**SUBJECT: MCI F3500 STEERING ARM IDLER BRACKET RECALL**

Ref.: NHTSA # 07V-191  
TRANSPORT CANADA # 07-146  
MCI Service Bulletin 279C

# Service Bulletin No. 279C

MODEL F3500 Series Coaches	TYPE Field Change Program	SECTION/GROUP 11-Steering	DATE Aug. 7, 2007
SUBJECT STEERING ARM IDLER BRACKET			
CONDITIONS

Figure 2. Top view of front bogie. Inspection required of four locations.

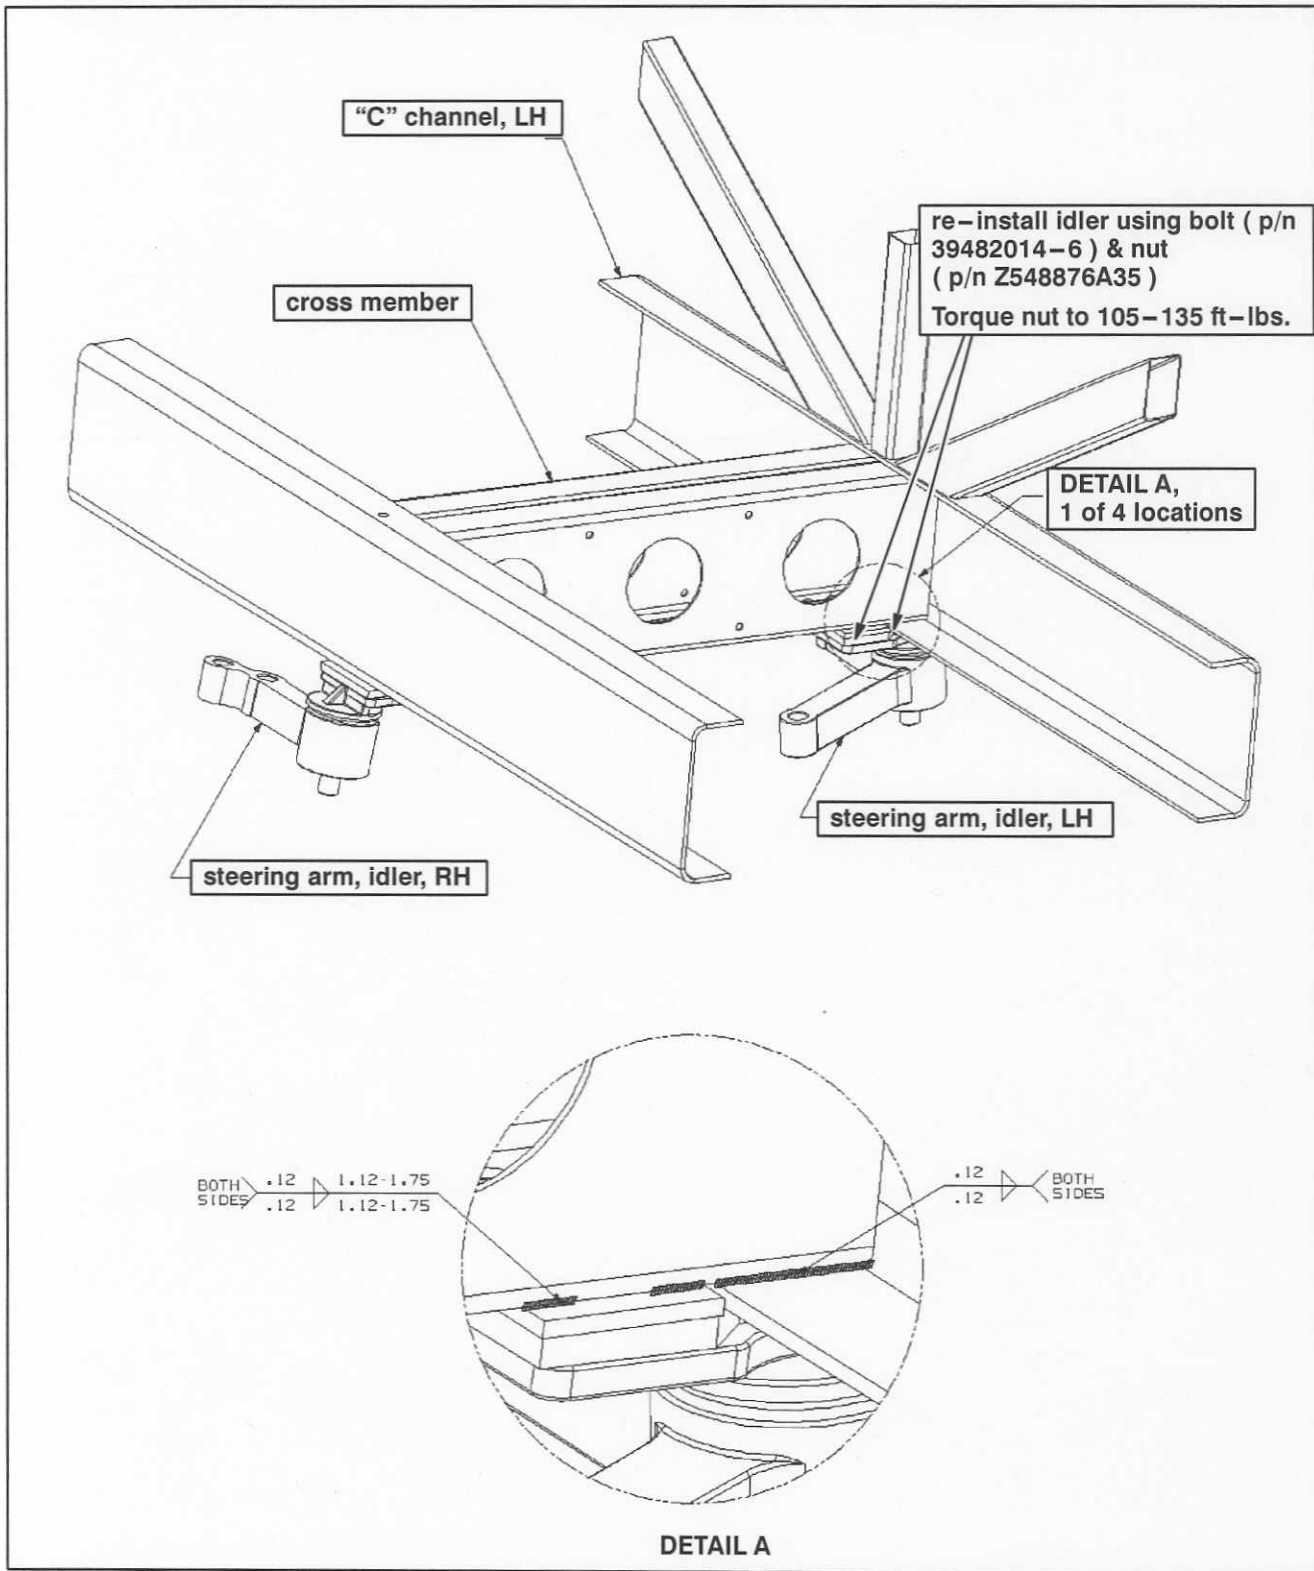
1. Turn the main disconnect switch to the OFF position.
2. Locate the steering arm idler brackets on the curbside and roadside of the front axle ( refer to Figure 2 ).
3. Remove steering arm idler and tie rods, if necessary. Discard existing steering arm idler mounting hardware.
4. Visually inspect the steering arm idler bearings for damage. Replace if necessary.

6. Inspect the four weld areas shown in Figure 2 / Detail A and the two weld areas shown in Figure 3 / Detail B.
7. If a crack is present, at the location shown in Figures 2 and 3:

- a. drill a 1/8 inch hole at the extreme end of the crack,
  - b. bevel both sides of the crack to create a V groove,
  - c. run a continuous weld, ensuring full penetration,

Figure 3. Bottom view of front bogie. Inspection required of two locations.

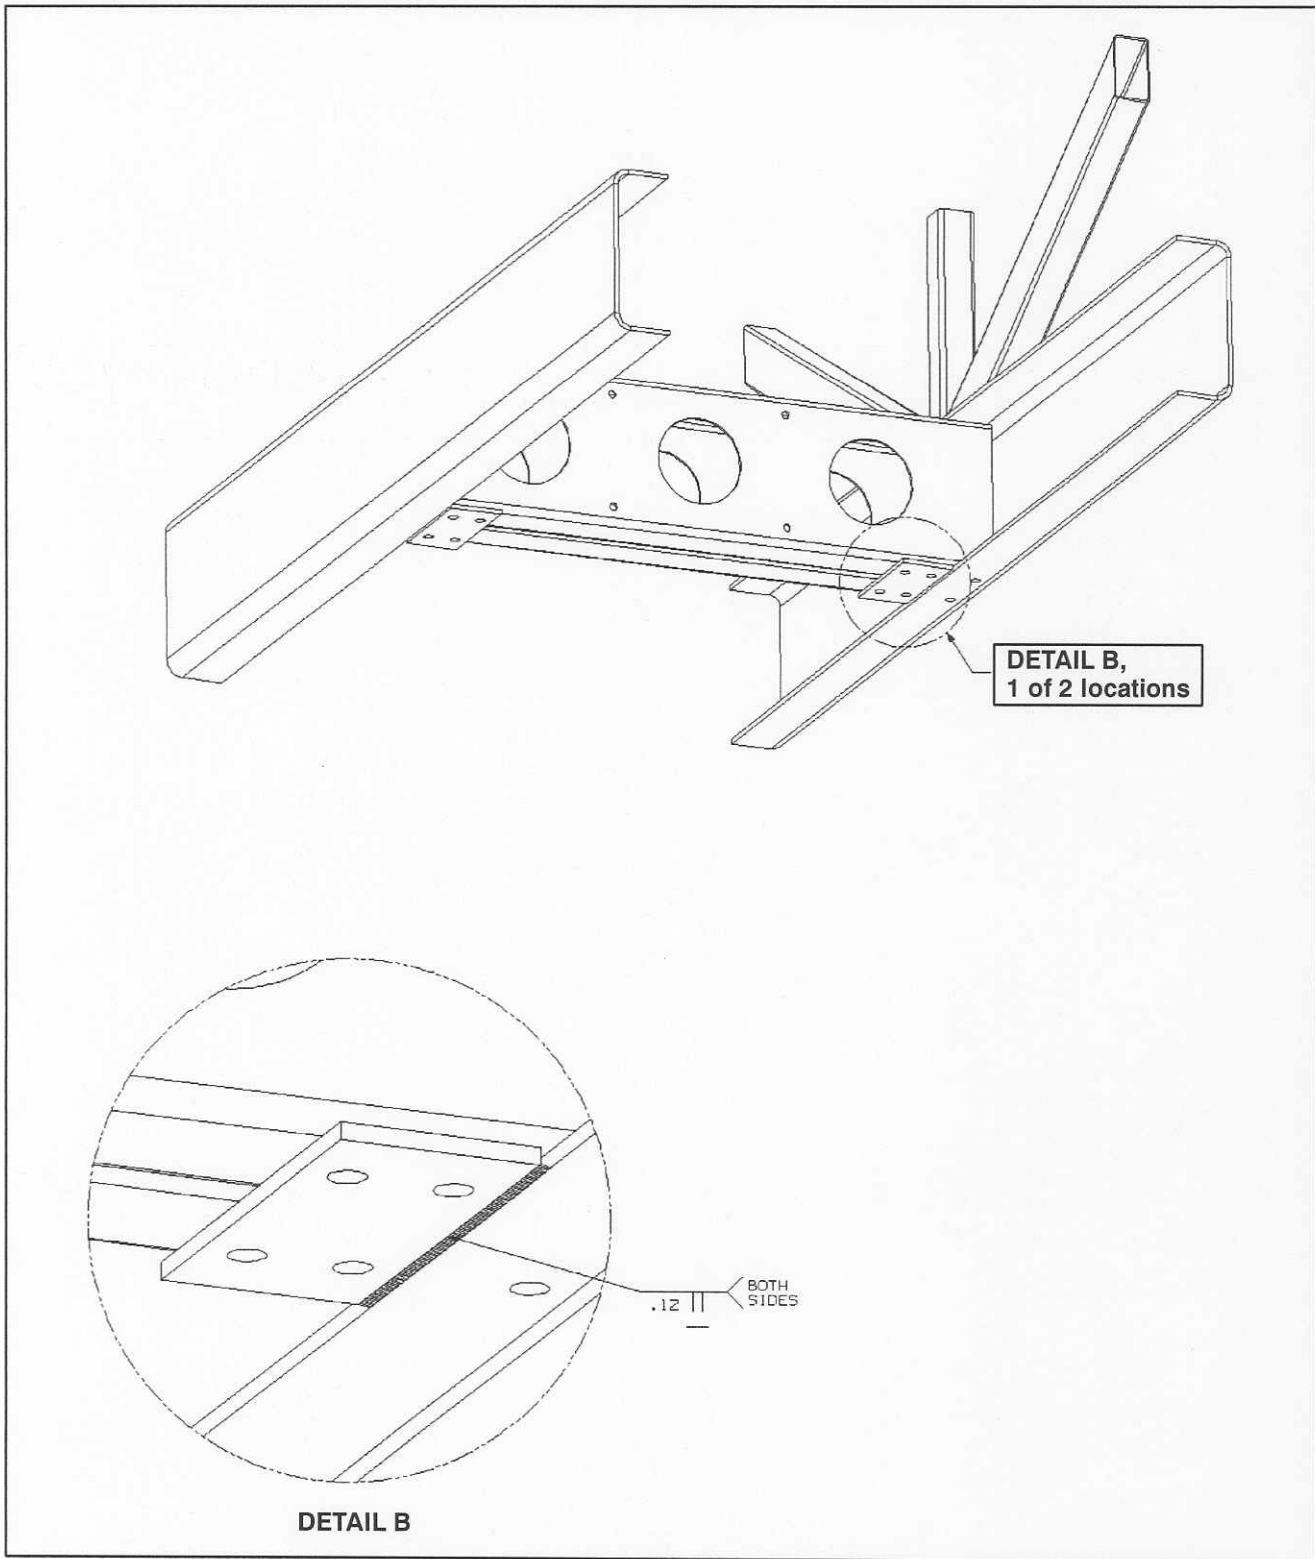
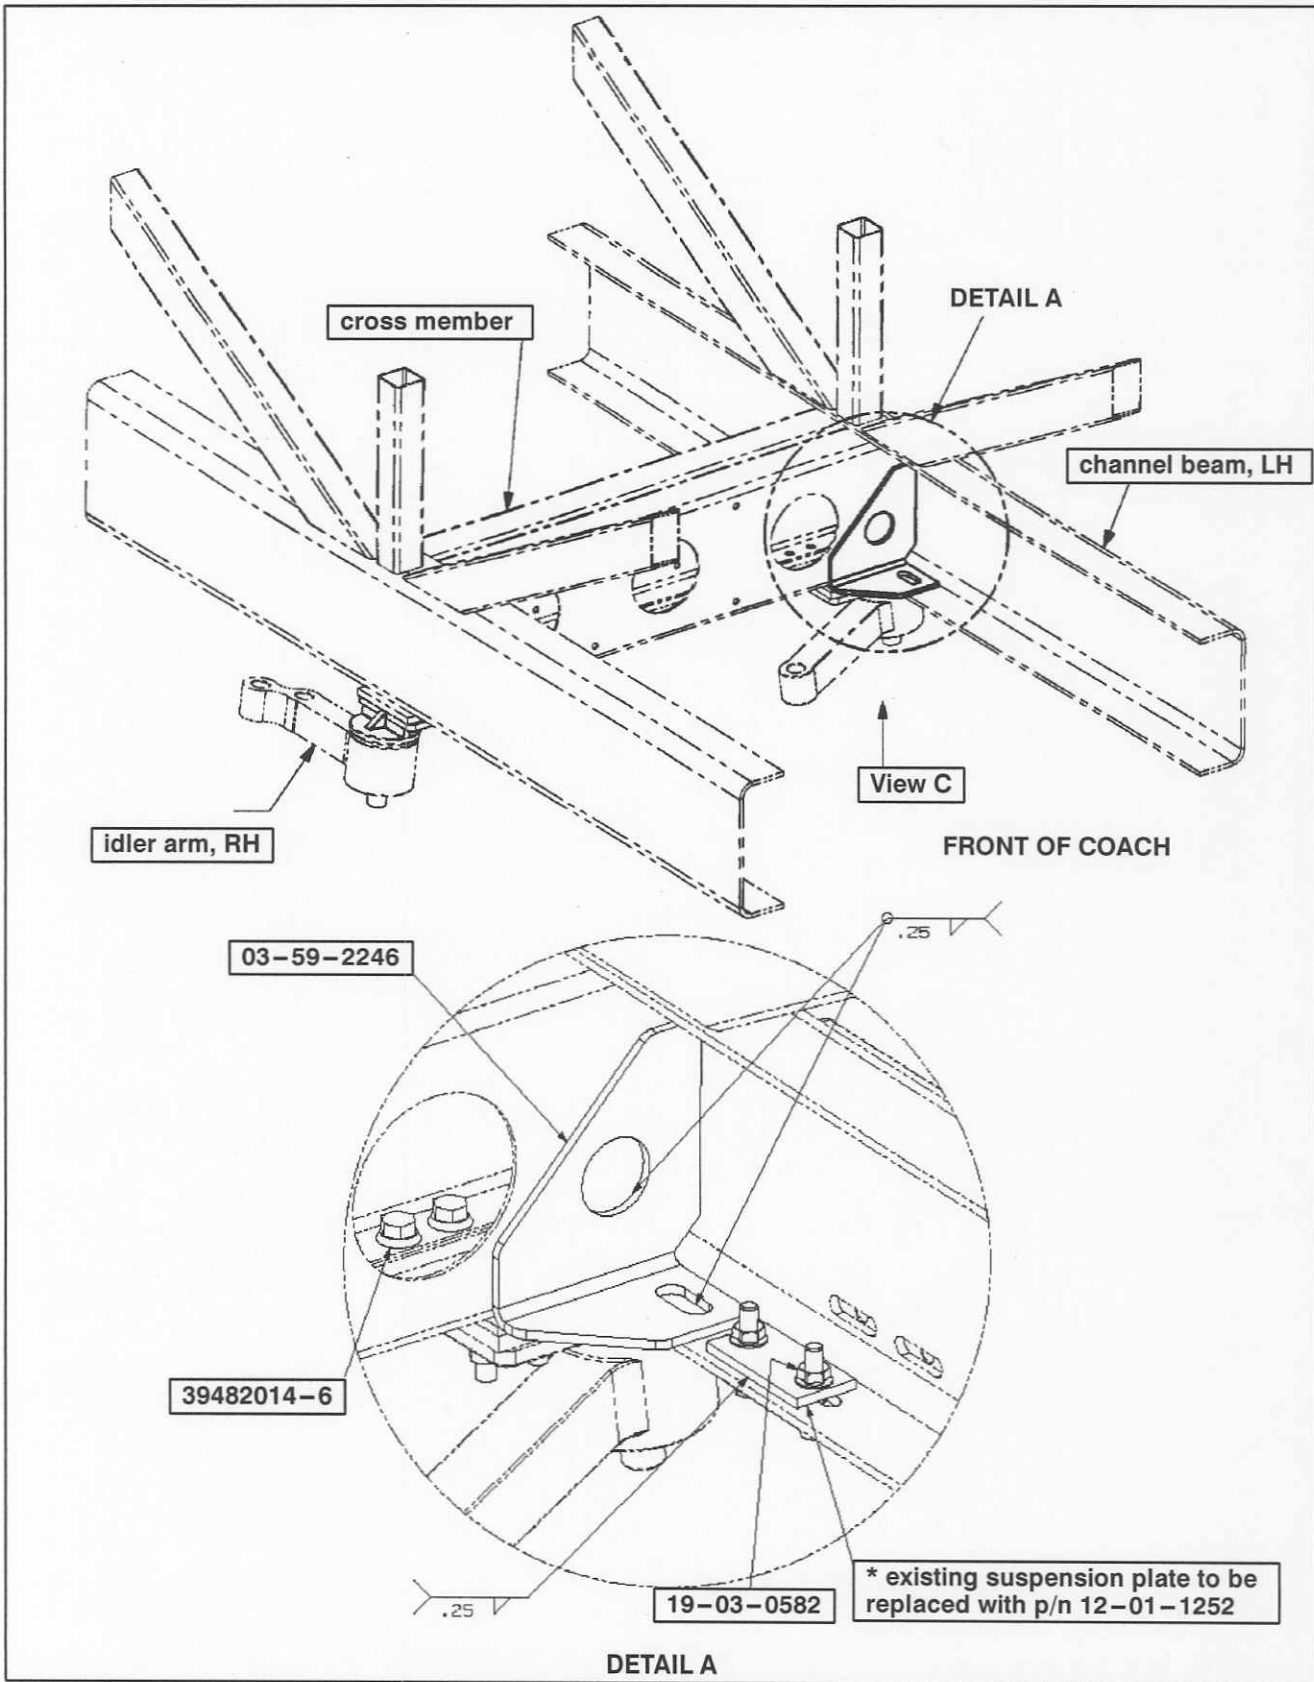
5. Using an industrial heat gun and steel brush, clean the four weld areas shown in Detail A and the two weld areas shown in Figure 3 / Detail B.

- d. grind the weld flush with the face of the plate.
8. Locate the existing suspension plate shown in Figure 4 / Detail A. Remove and discard the existing suspension plate and mounting hardware. Install the new suspension plate ( p/n 12-01-1252 ) using the mounting hardware provided ( p/n 19-1-994, 19-02-0383 and 19-03-0582 ). Hand-tighten and snug the nut's. Repeat to the opposite side. Weld the suspension plates, using the weld size and location in Figure 4 / Detail A.

9. Tack weld the angles ( p/n 03-59-2246 and 03-59-2247 ) into position, according to Figures 4 and 5.
10. Weld the angles, using the weld sizes and locations in Figures 4, 5 and 6.

11. Apply rust paint to the installation area.
12. Torque the suspension plate nut's to 50–75 ft.-lbs.
13. Re-install the steering arm idler, removed in Step 3. , using bolt ( p/n 39482014-6 ) and nut ( p/n Z548876A35 ) ( Figures 4, 5 and 6 ). Torque nut to 105–135 ft.-lbs.
